3016-3032 KIRWIN
AVENUE

Transportation Impact Study Update

December 2022
21111

RE: Transportation Impact Study for the Stacked Townhouse Condominium Development at 3016-3032 Kirwin Avenue, Mississauga, Ontario

Figure 1-1: Site Plan (Source: KFA Architects + Planning Inc., dated October 11, 2022)

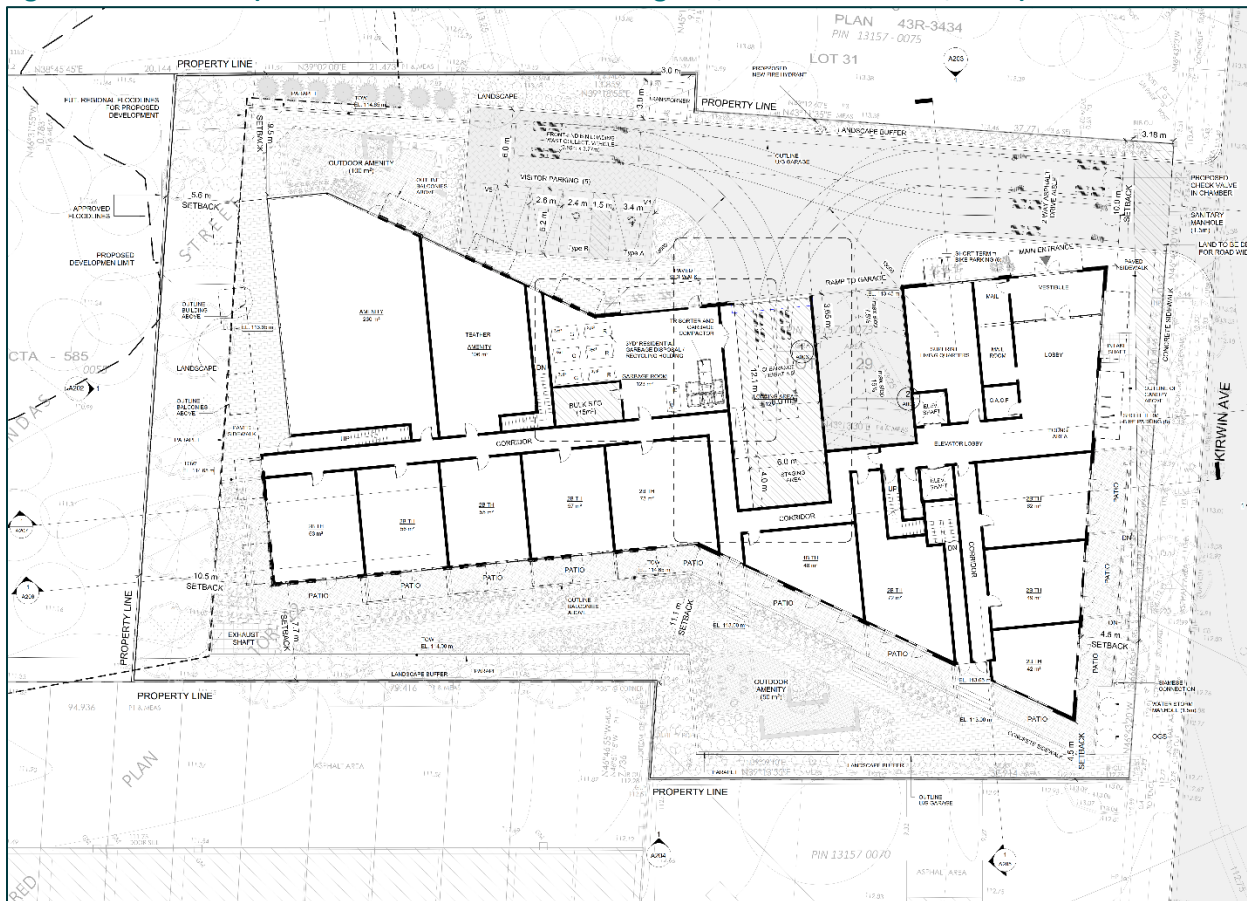
(a) The proposed access shall be relocated to align with the opposing access to the plaza

Response: Given the configuration of the site, realigning the access would create significant impacts to the built form, specifically as the access is currently located within required setbacks and is an efficient use of

the at-grade area. As the proposed location provides more distance from the intersection at Dundas, this location is considered to be appropriate. The access review is discussed in further detail in Section 7.

GROUND FLOOR
FIRE ROUTE

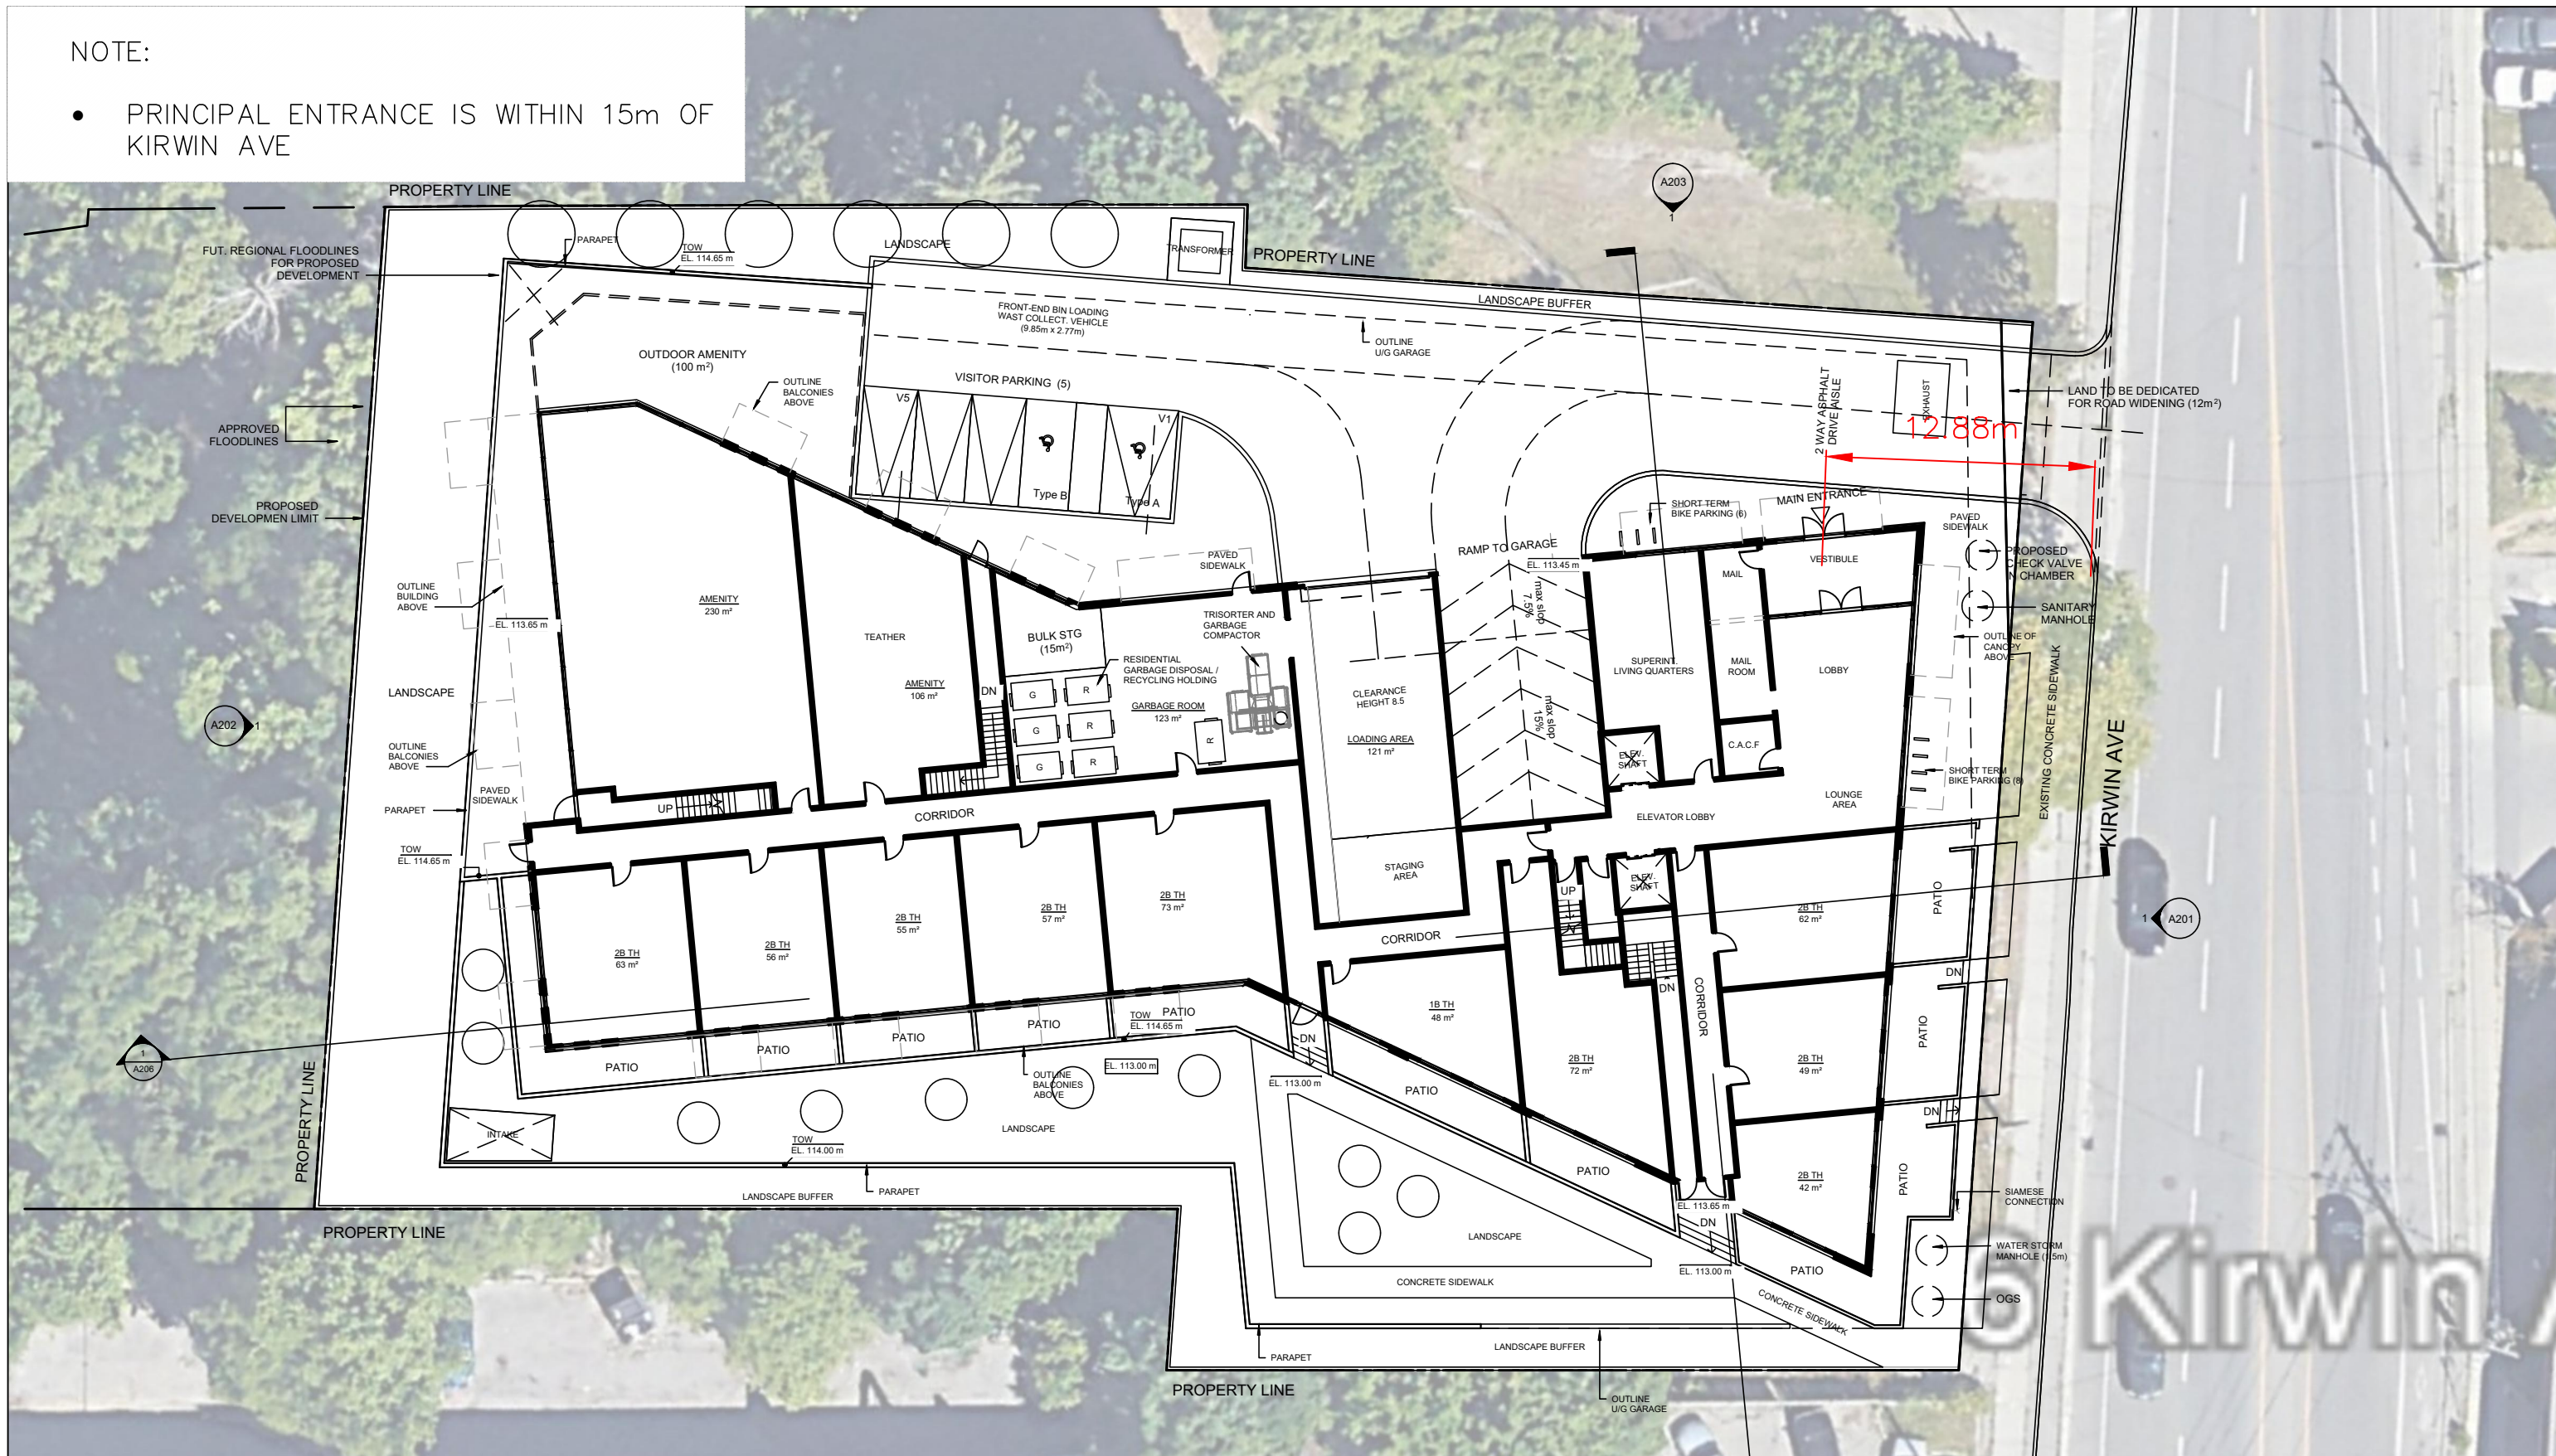
(a) Confirmation from Fire and Emergency Services that the internal road is acceptable from an emergency response perspective.

Response: The Site Plan complies with City of Mississauga Fire Route requirements, including:

- *Overhead clearance is greater than 5.0m*
- *The principal entrance is located less than 15m from Kirwin Avenue*
- *The access is greater than 6m in width*
- *Centreline radius of 12m is provided*

GROUND FLOOR
 PEEL REGION GARBAGE TRUCK
 ENTRY PATH

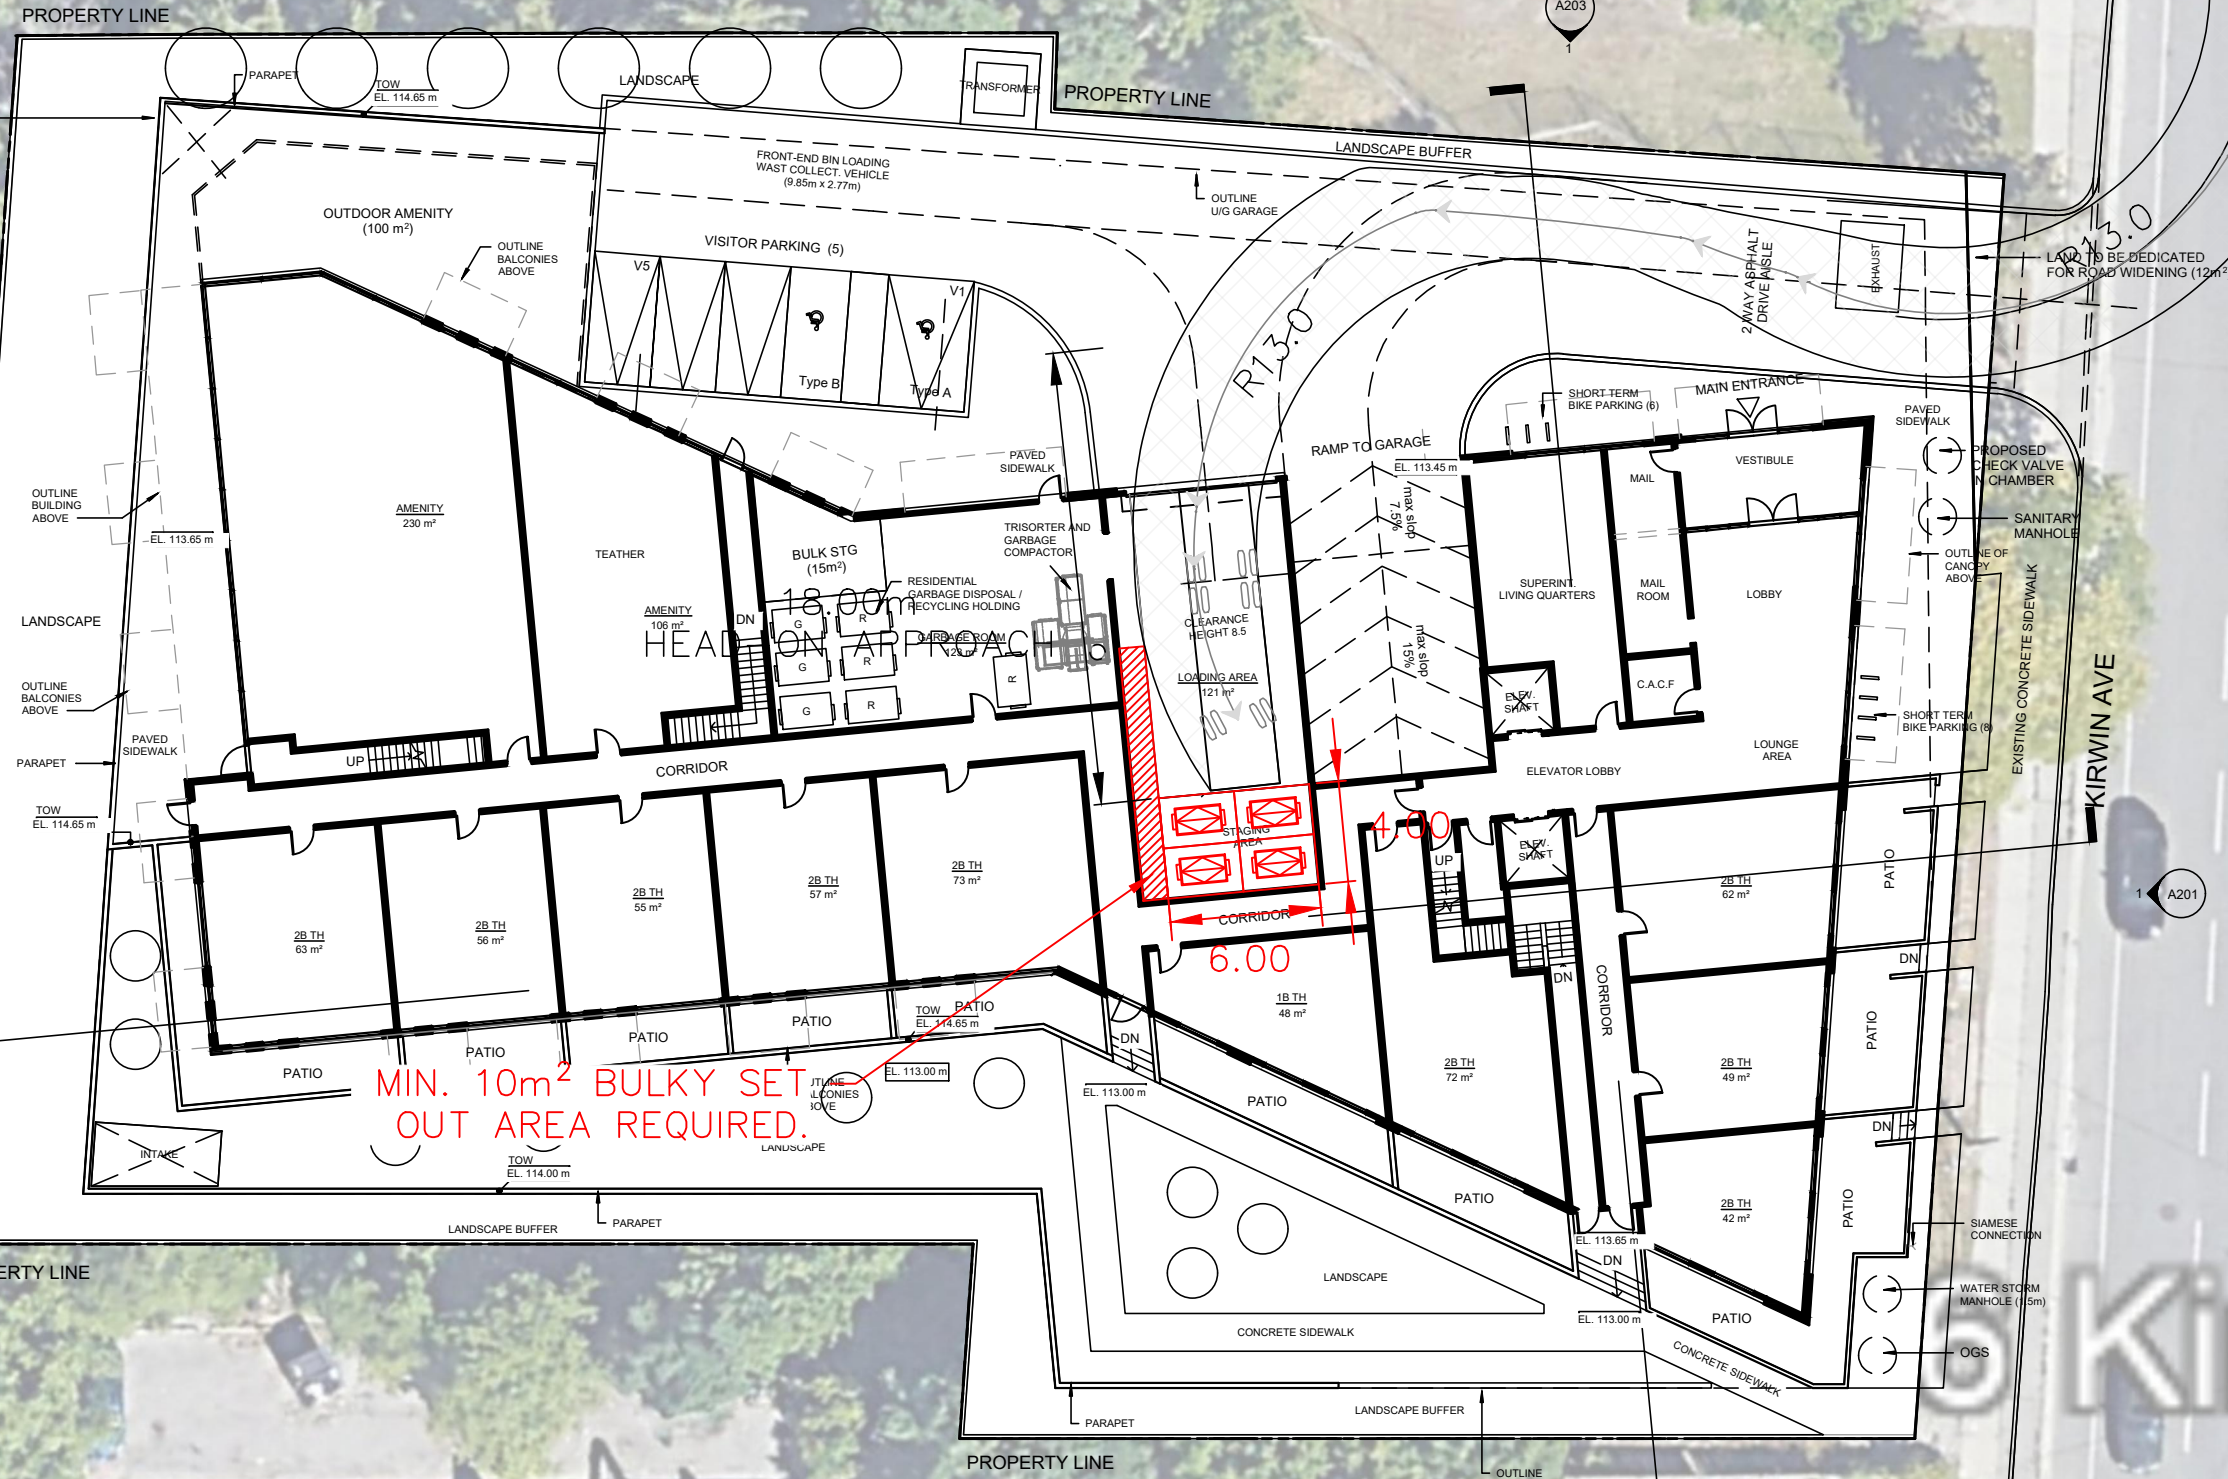
(b) Confirmation from the Region of Peel that the internal road is acceptable from a waste collection perspective.
